**R17-077-04
LOYALHANNA APARTMENT RENOVATIONS**

REBID ADDENDUM NO. 1

DATE OF ISSUE: MAY 17, 2019

1 TYPICAL FLOOR (2 THROUGH 8 FLOORS) - LIGHTING & POWER PLAN
E-301 SCALE: 1/8" = 1'-0"

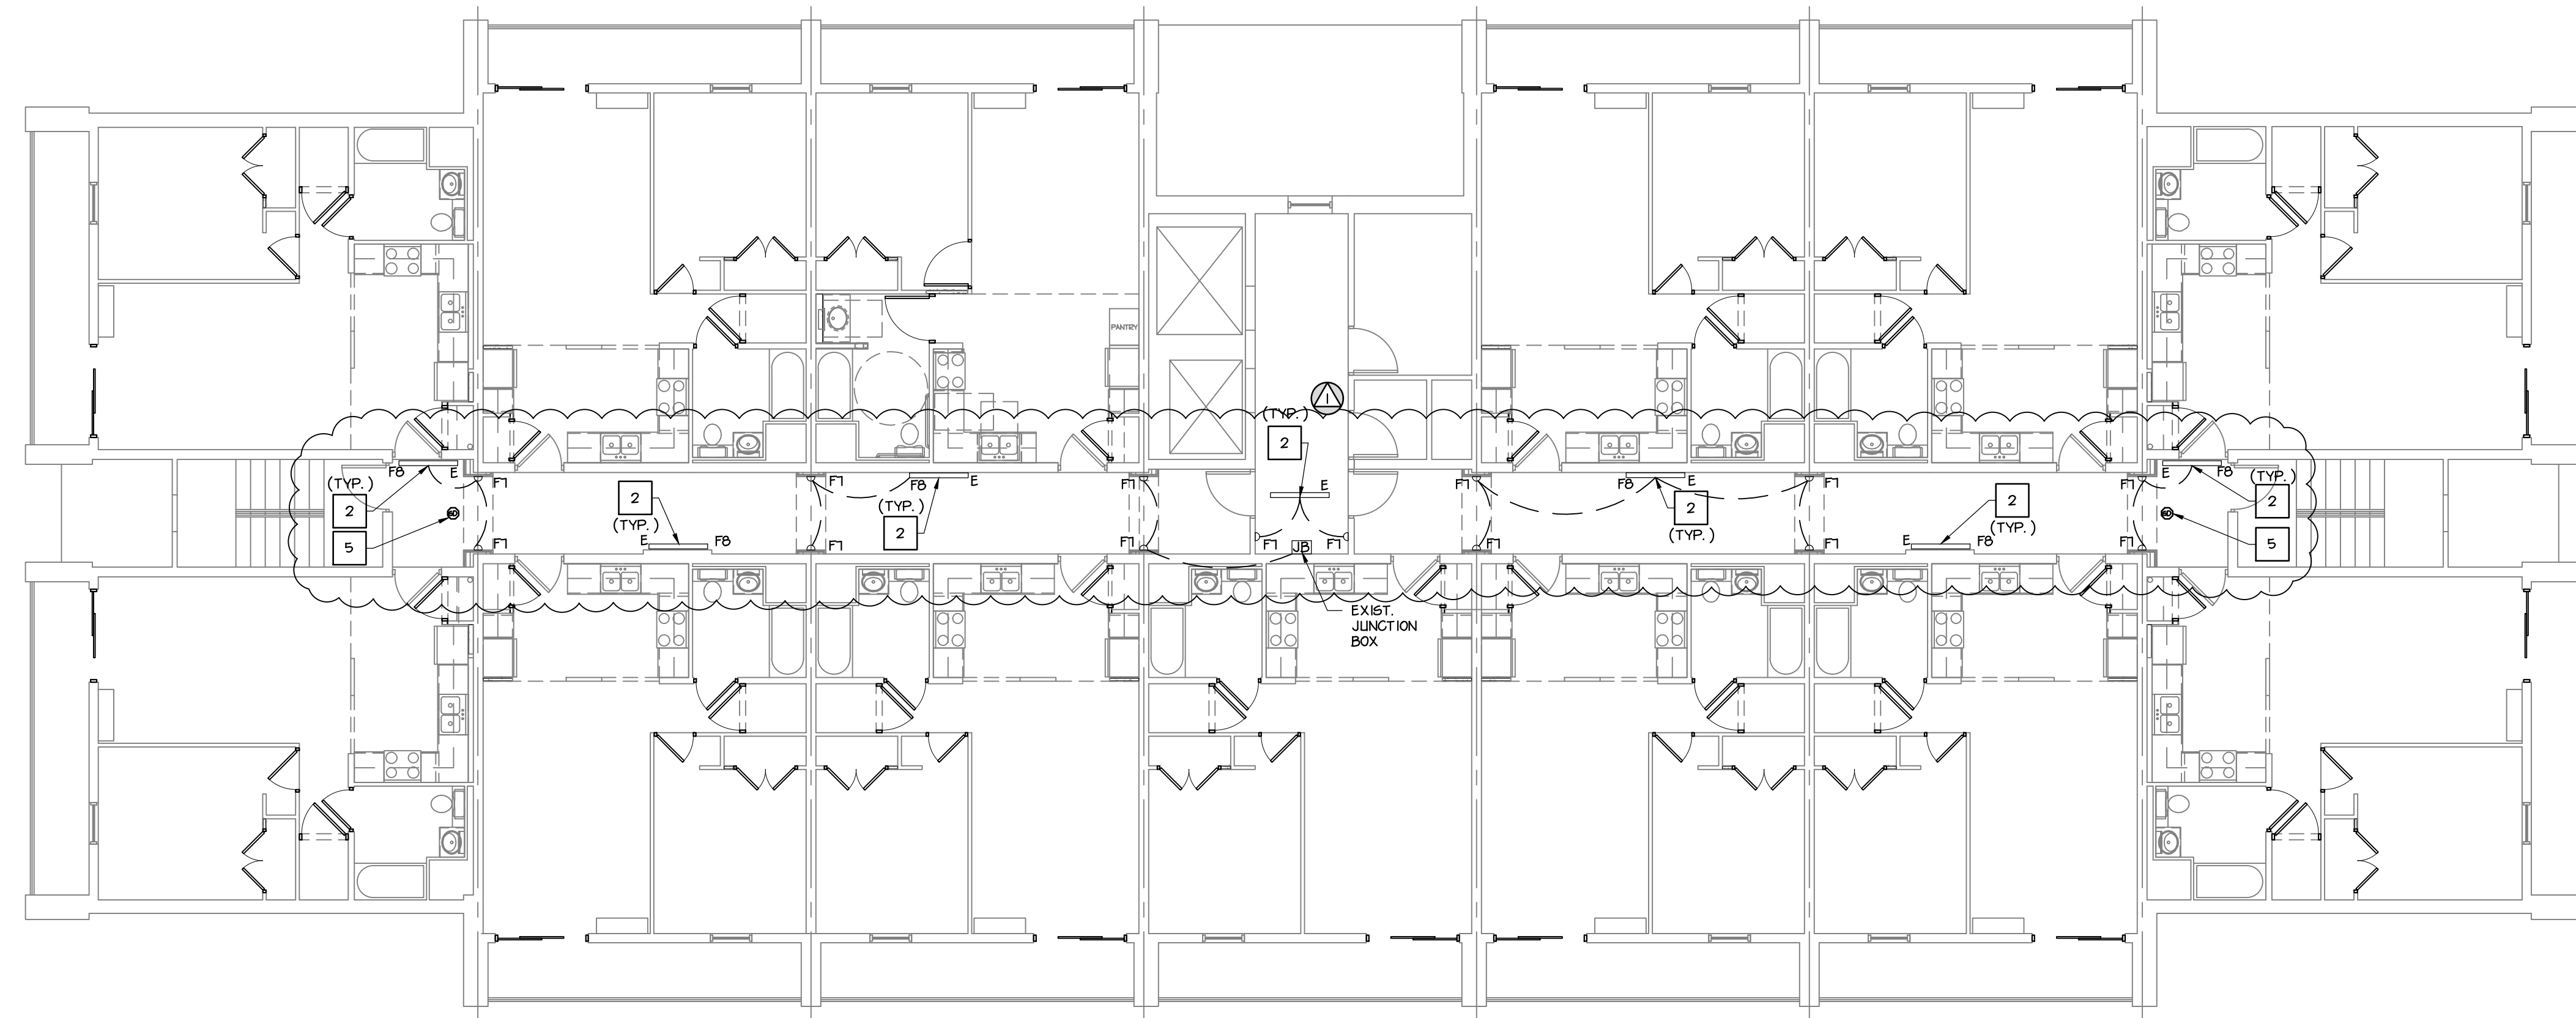
E-301 ELECTRICAL LIGHTING AND POWER PLAN

Revise Drawing as indicated on the attached drawing E-301

Revise: Adjust location of light at stairwell door to provide adequate space for new Pilaster.
Coordinate with GC.

5 ACCESSIBLE APARTMENT -
LIGHTING & POWER PLAN
E-302 SCALE: 1/4" = 1'-0"
PLAN NORTH

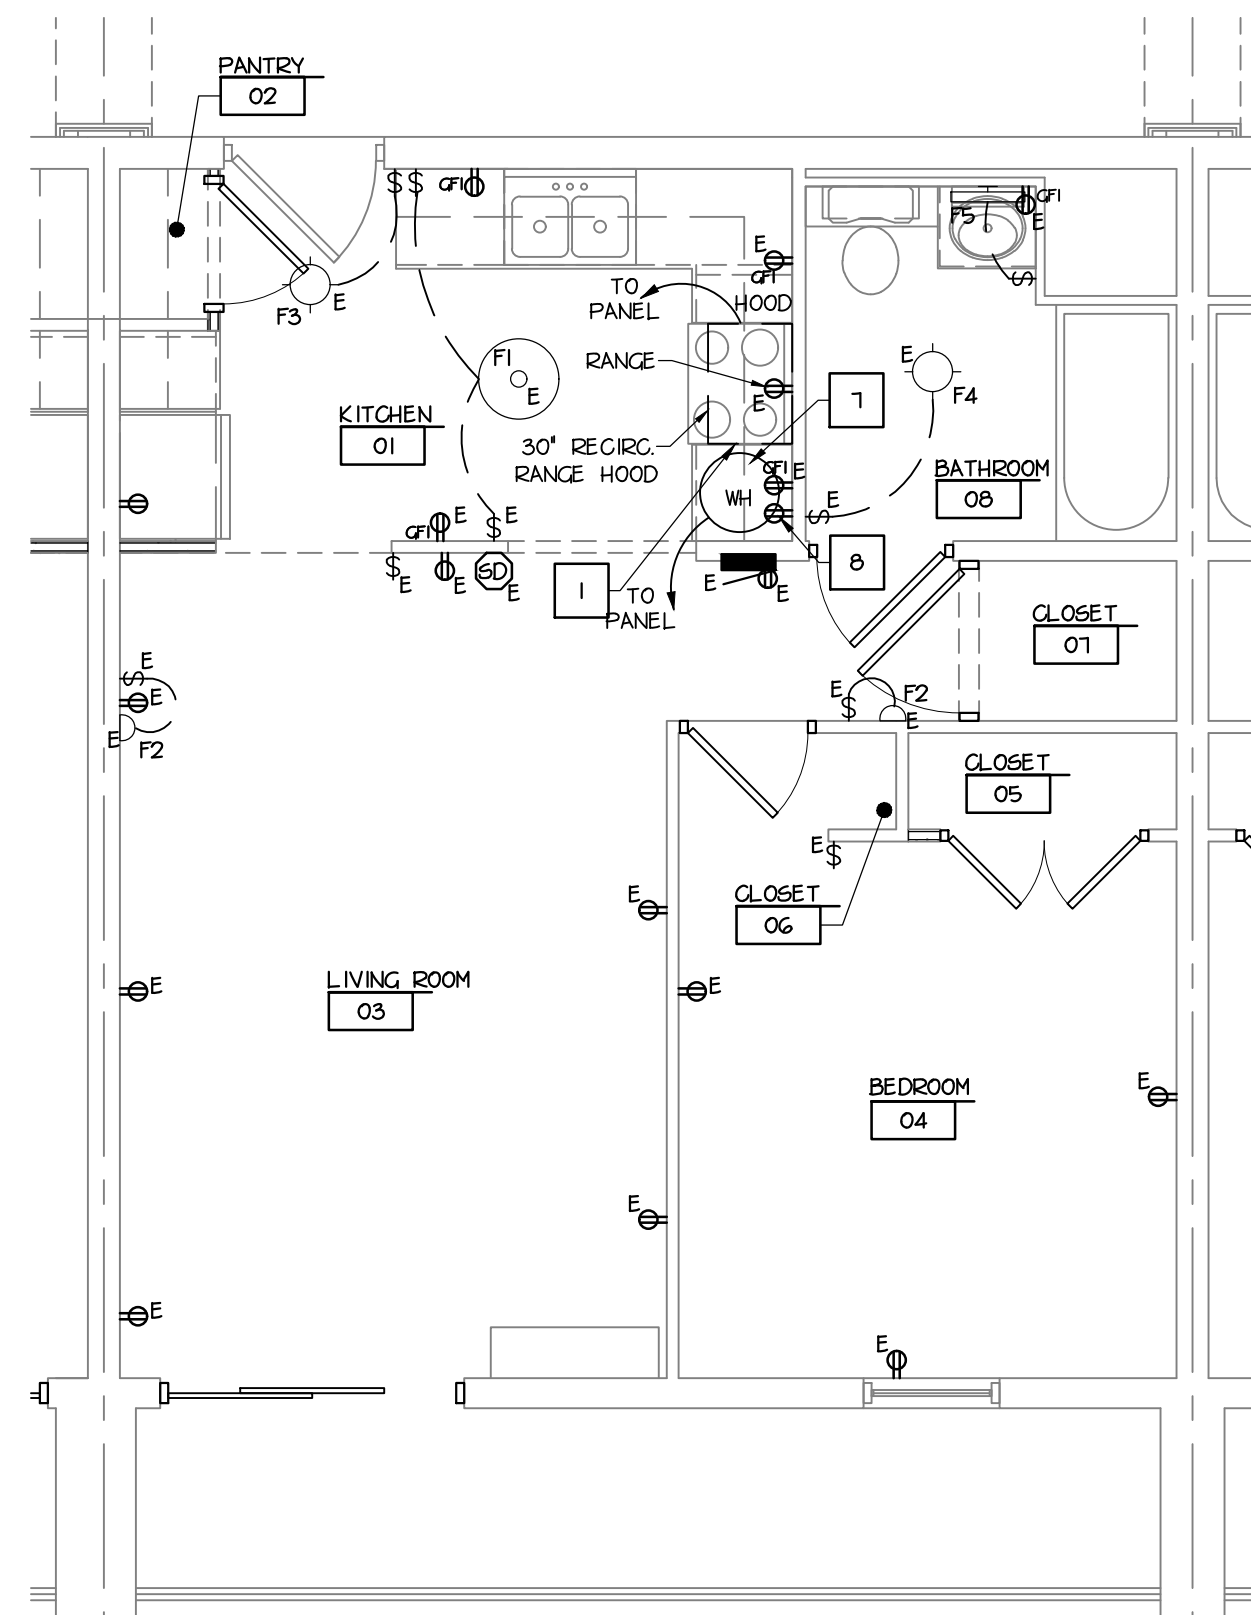
Detail 5/E-302

Clarification: EC is to locate the switch, outlet and sconce beyond the pantry cabinet between the Kitchen and Living Room. Provide new wiring and raceway if required.

Clarification: EC is to locate the receptacle on the living room wall between the Living Room and Bedroom. Provide new wiring and raceway if required.

3 APARTMENT TYPE 'A' -
LIGHTING & POWER PLAN
E-302 SCALE: 1/4" = 1'-0"
PLAN NORTH

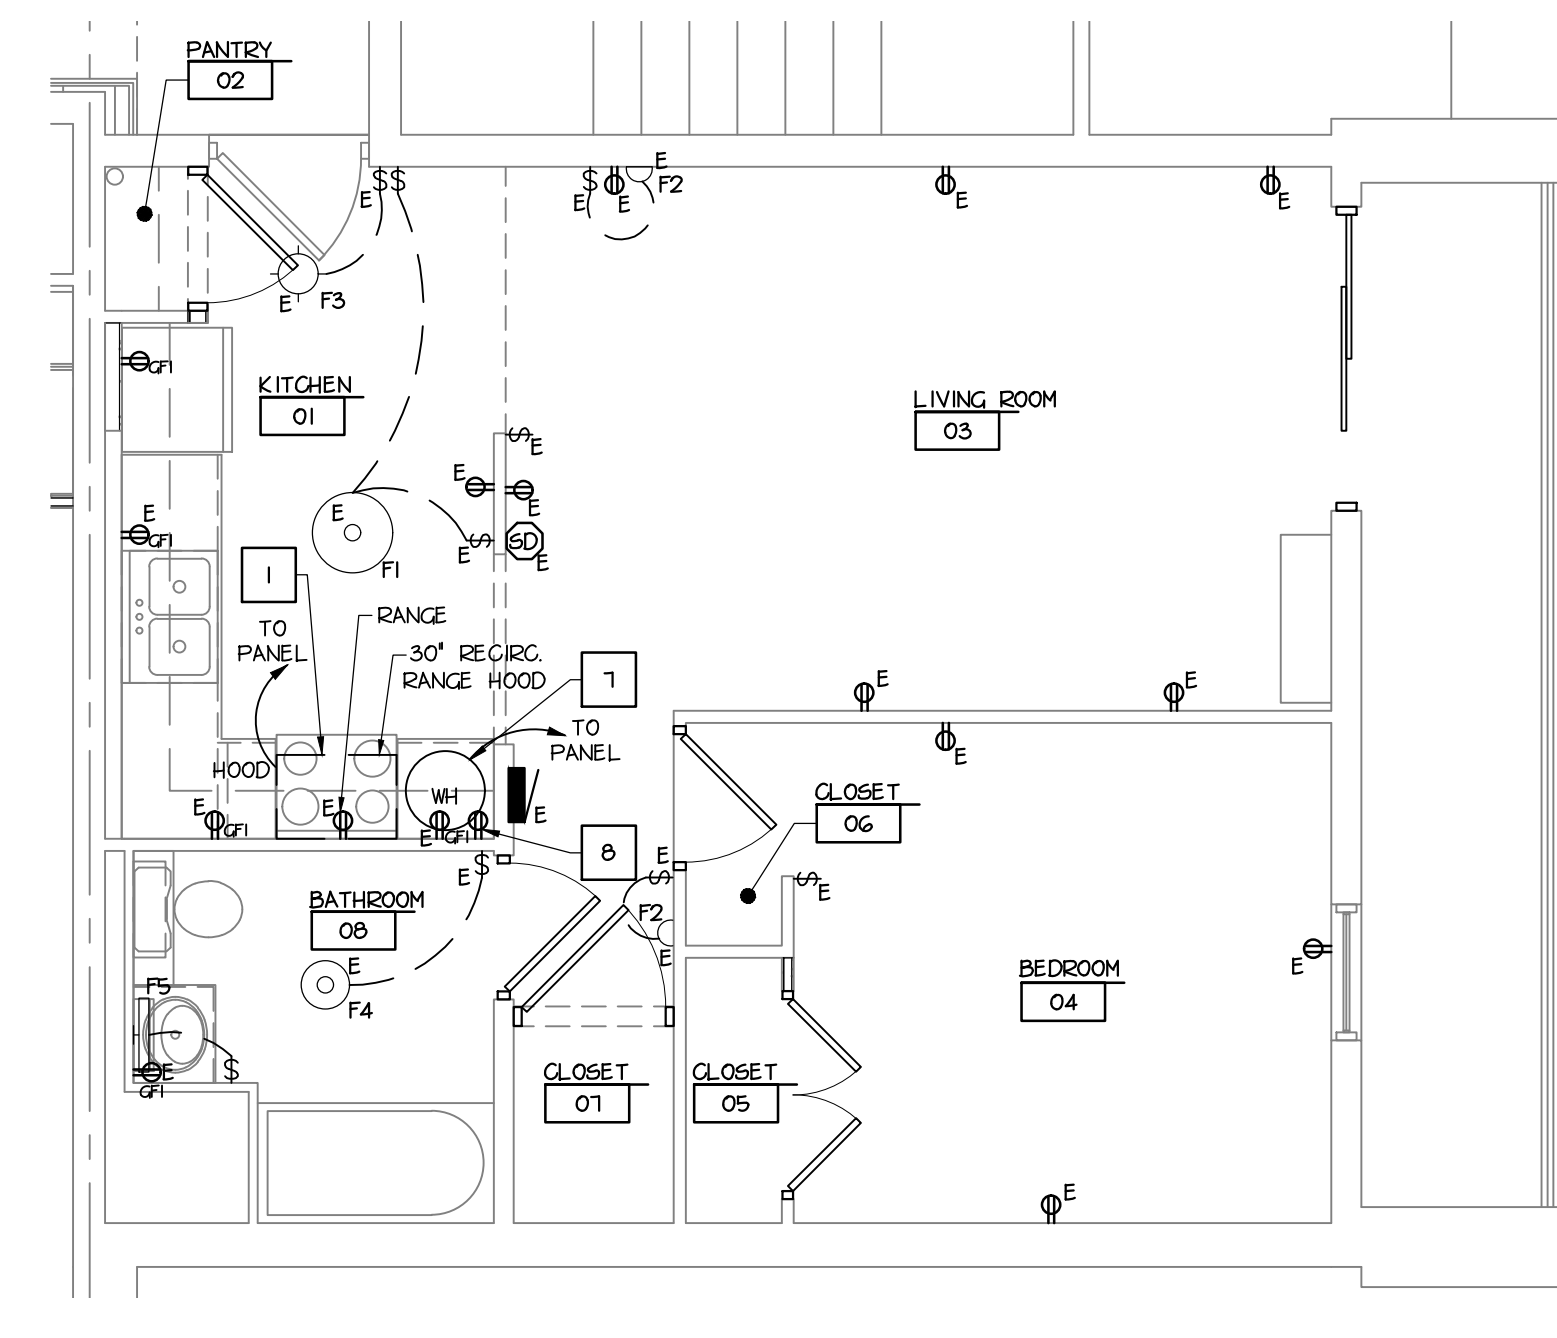
Detail 3, 4/E-302

Clarification: EC is to provide a new receptacle for the refrigerator. Provide new wiring and raceway if required.
